CITY OF ALBUQUERQUE

RE: 1009 Cuatro Cerros Trail SE
Grading and Drainage Plan
Engineer's Certification Date: 07/27/20
Engineer's Stamp Date: 03/10/20
Hydrology File: M22D018

DRAINAGE AND TRANSPORTATION INFORMATION SHEET (REV 6/2018)

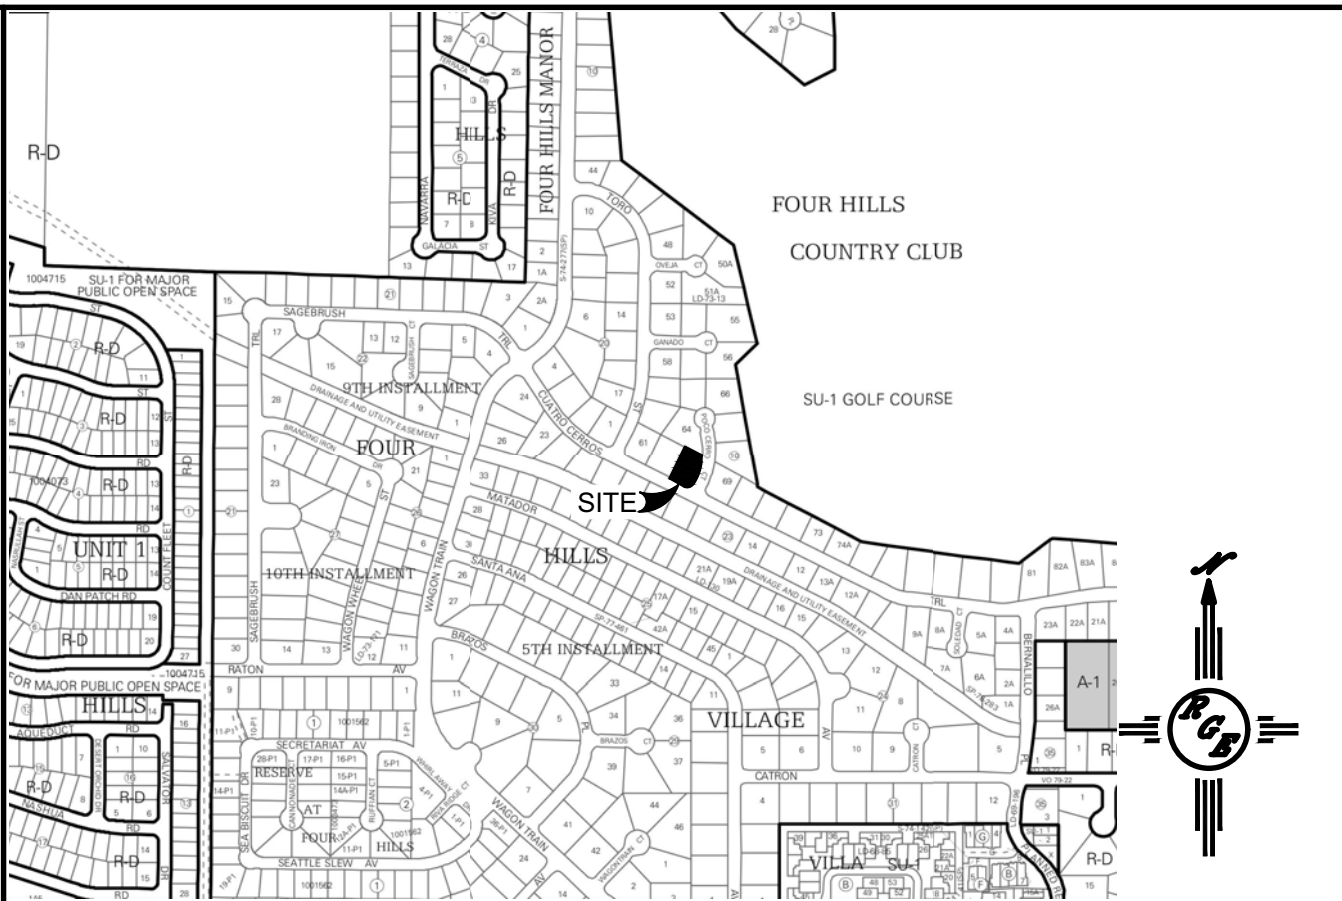
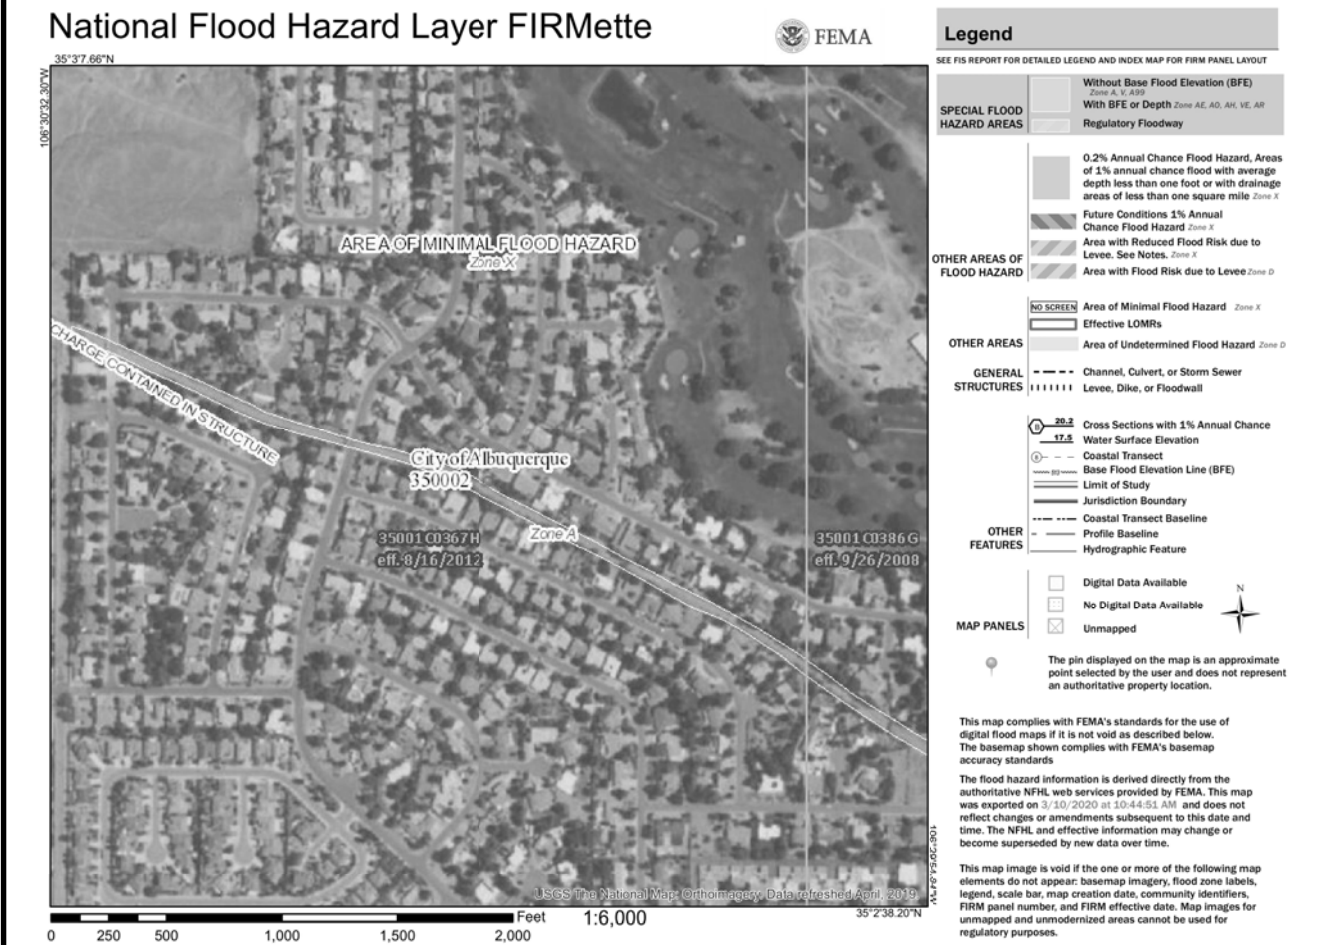
Based upon the information provided in your Certification received on 07/29/20 and site photos sent on 07/29/20, the above referenced Certification is acceptable for Building Pad Certification for 1009 Cuatro Cerros Trail SE.

Prior to approval in support of Permanent Release of Occupancy by Hydrology, Engineer Certification per the DPM checklist will be required.
